A303 Amesbury to Berwick Down

**8.46 – Response to English Heritage objection to PRow to
Visitor Centre**

Response to English Heritage objection to PRow to Visitor Centre

Regulation Number:	Regulation 5(2)(q)
Planning Inspectorate Scheme Reference	TR010025
Application Document Reference	8.46
Author:	A303 Amesbury to Berwick Down Project Team, Highways England

Drawing Title
**NMU OPTION 10
A360 TO STONEHENGE
VISITOR CENTRE
OVERVIEW**

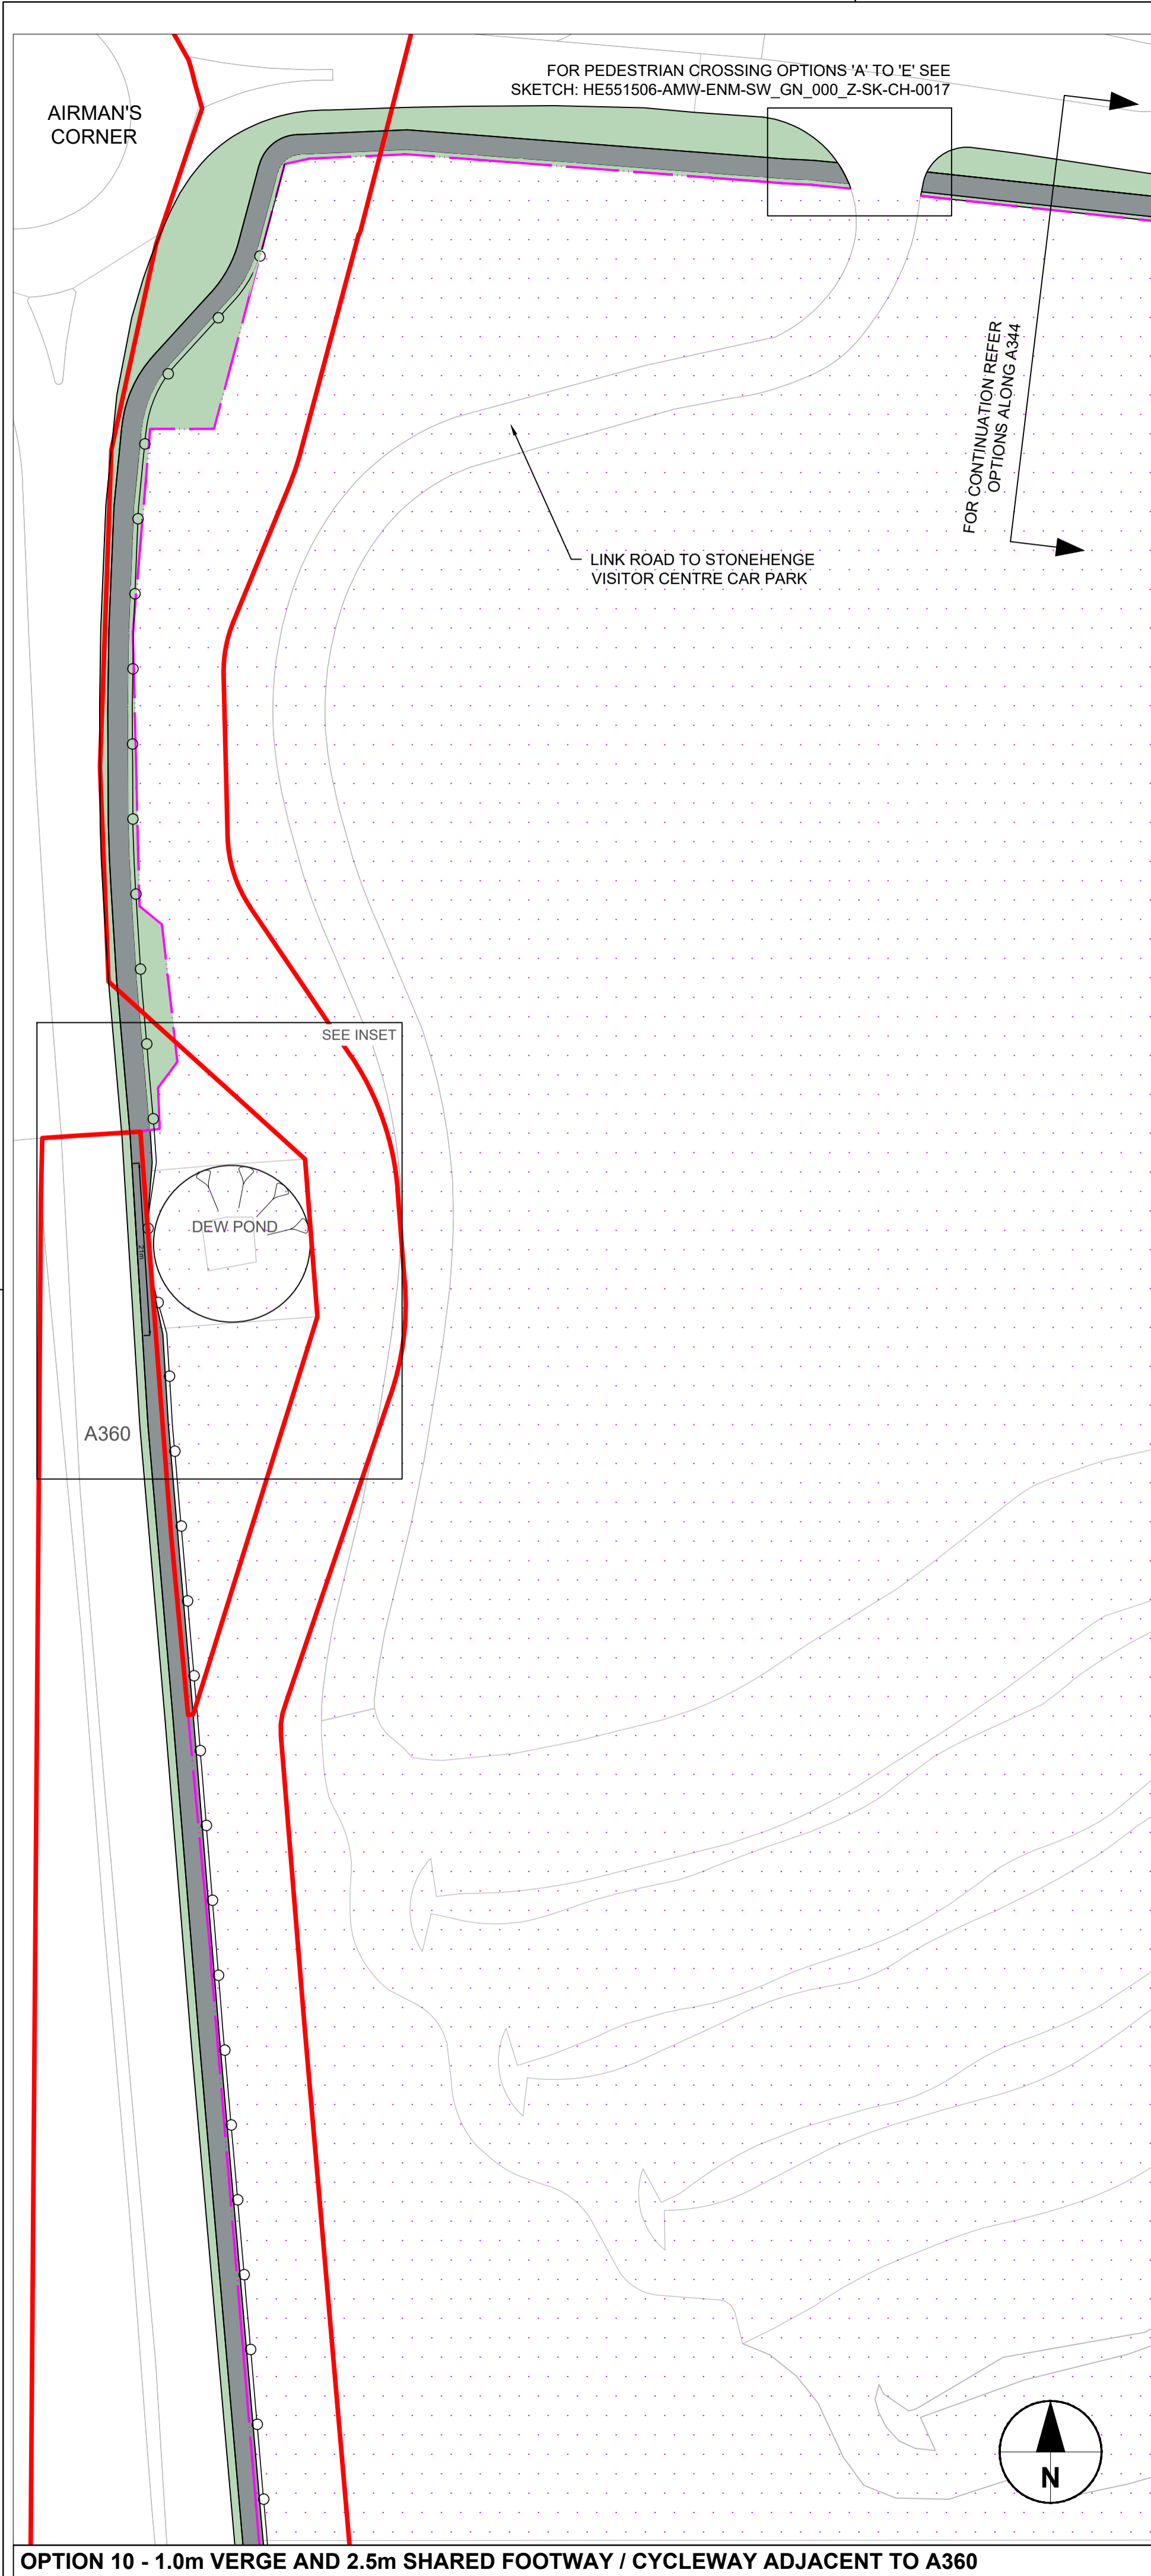
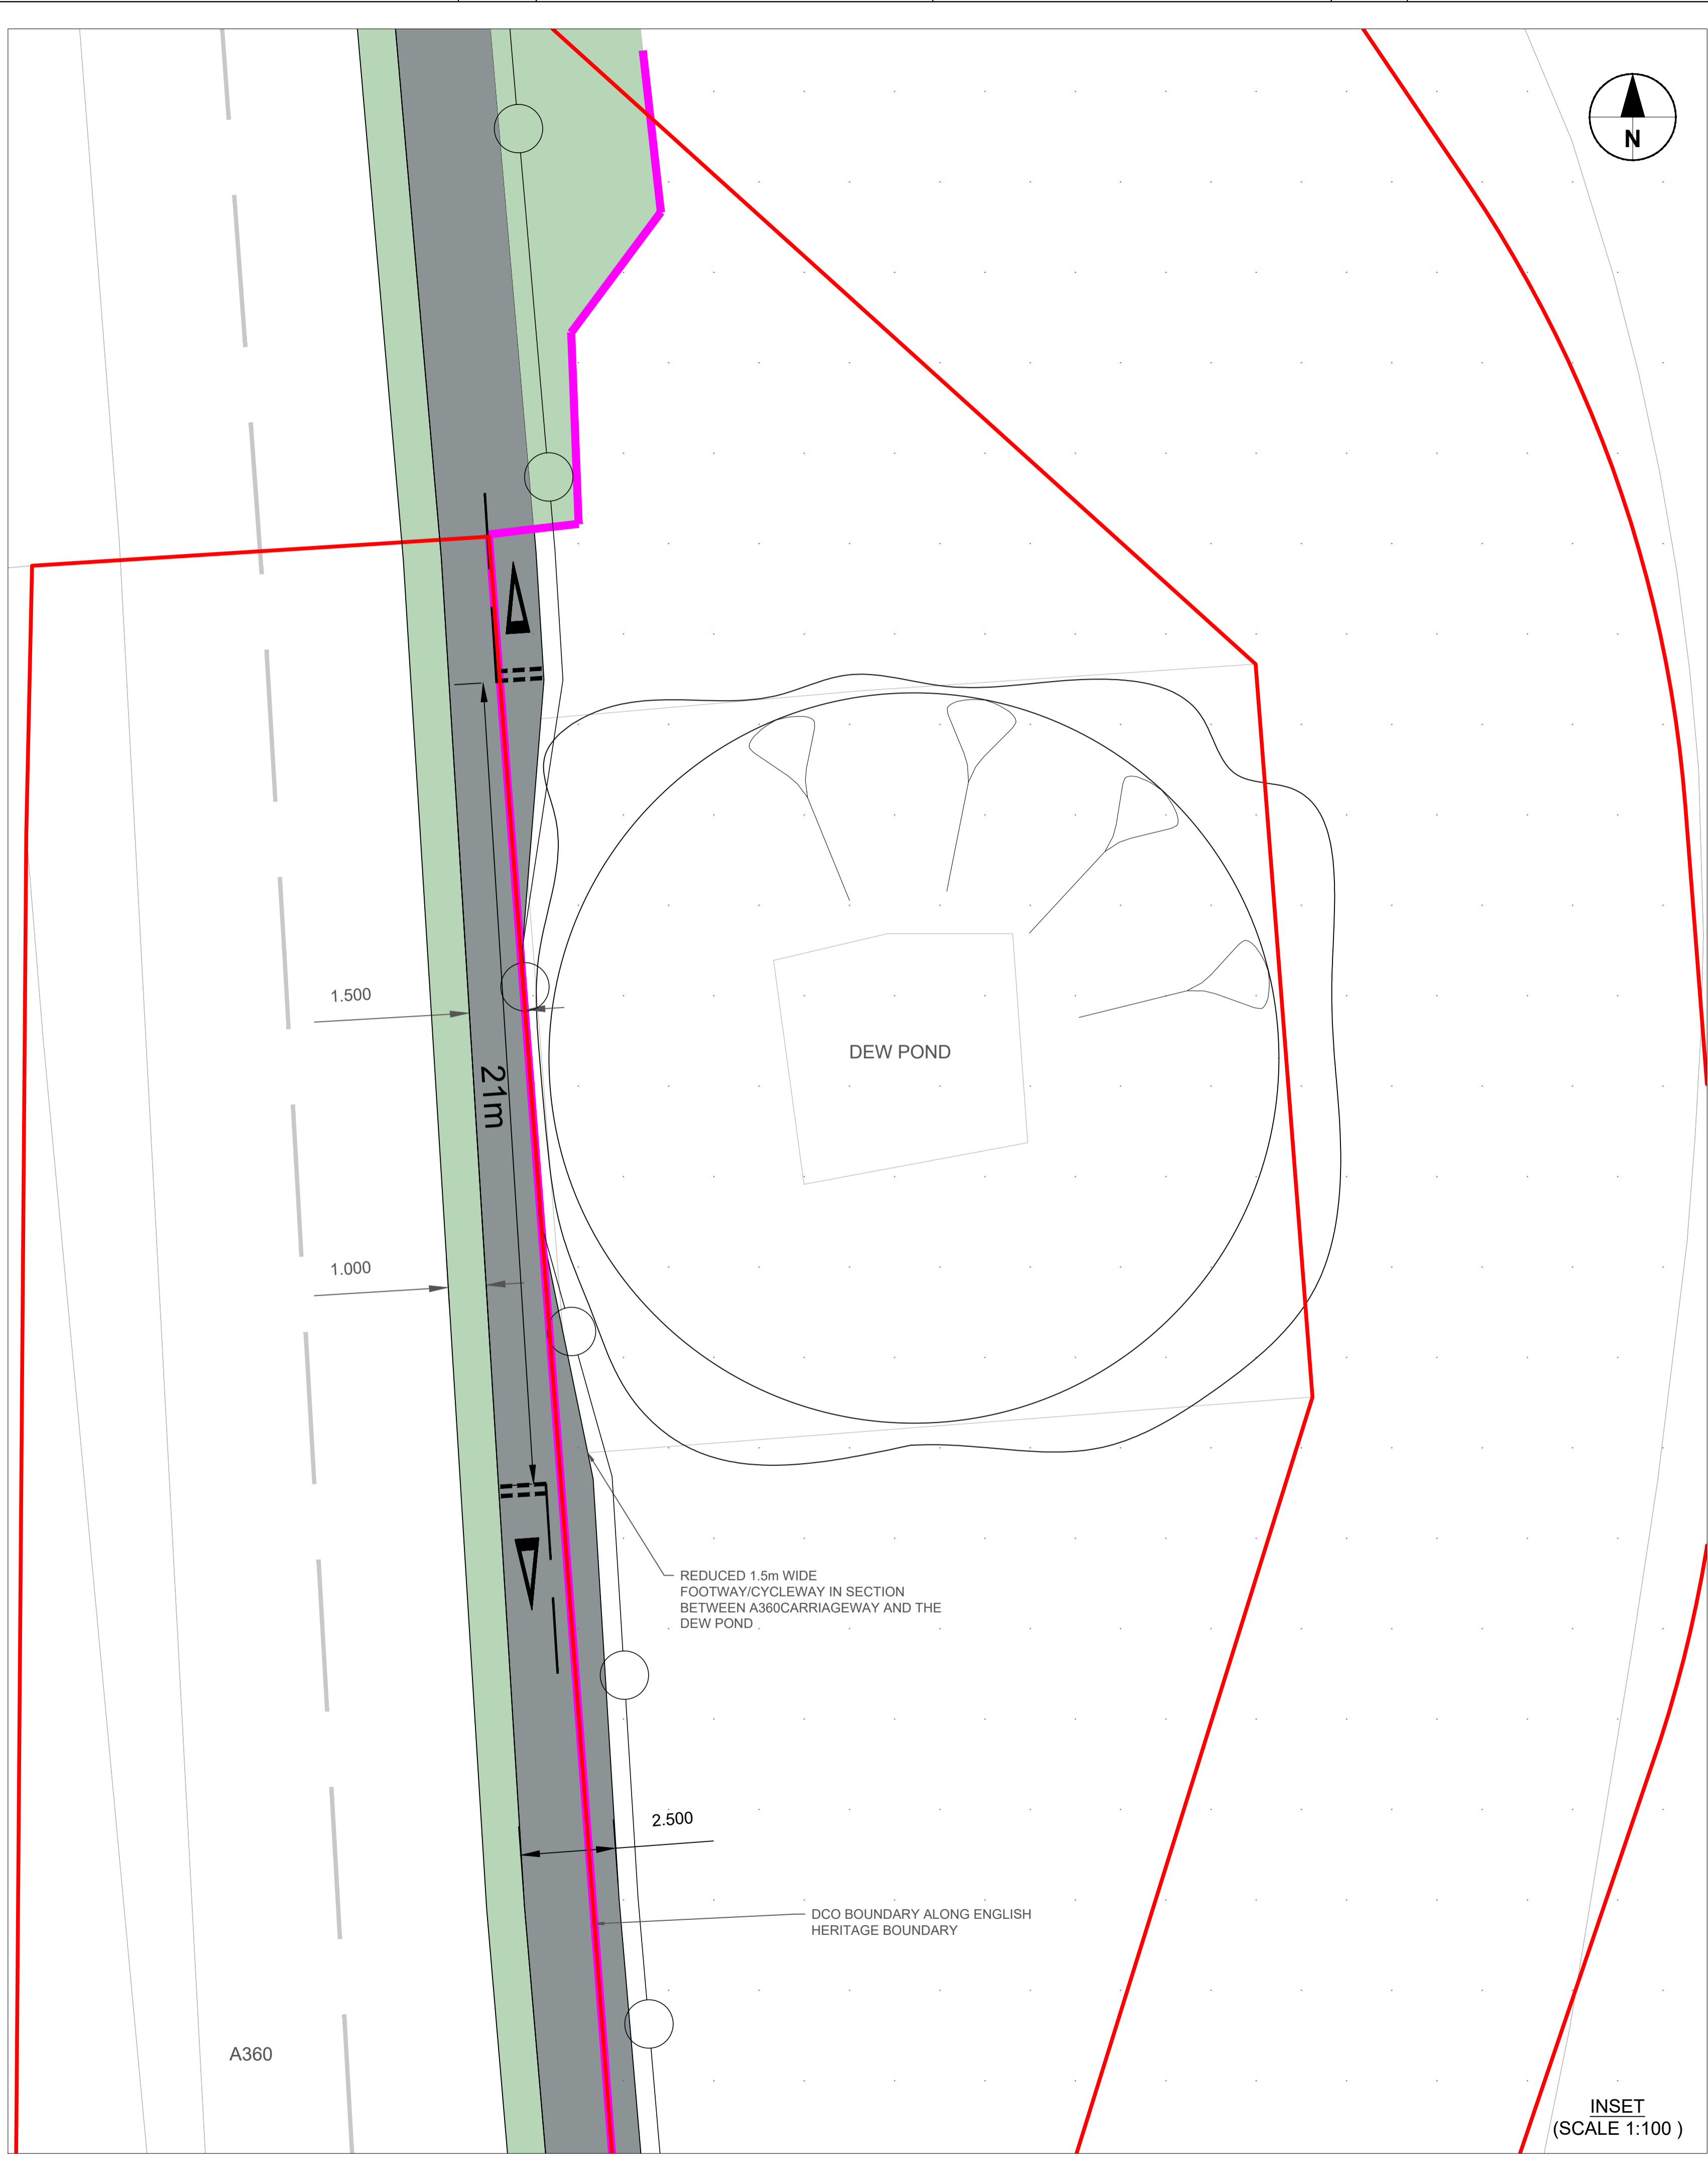
- 5.1.1 Option 10 includes a proposed shared-use cycleway link on the eastern side of the A360, routed to the west of the Dew Pond. This option includes a 1.0m wide verge next to the A360 and a shared pedestrian / cycle facility 2.5m wide. This option has a reduced width of 1.5m past the dew pond. This option then continues alongside the C506 (former A344) crossing the car park entrance and terminating opposite the coach park access road in order to provide a connection to the World Heritage Site.

- 5.1.2 Option 10 significantly reduces the area of land proposed to be subject to compulsory acquisition compared with the DCO proposals and reduces the area by which overflow parking within the Visitor Centre site would be reduced. The area of land proposed to be acquired from within the Visitor Centre site for the purposes of the current DCO proposal is 3,527 square metres; in contrast, the area required for option 10 is only 228 square metres. However, 77m² of this, and a further 65m² not within EHT ownership, would be outside the Order Limits where the shared-use cycle route passes to the west of the Dew Pond. Depending on the option selected to extend the shared-use cycle route along the C506, further land outside the Order Limits would be required (see section 6 below).

- 5.1.3 Option 10 is shown on drawing HE551506-AMW-ENM-SW_GN_000_Z-SK-CH-0023 in Appendix 3 to this report.
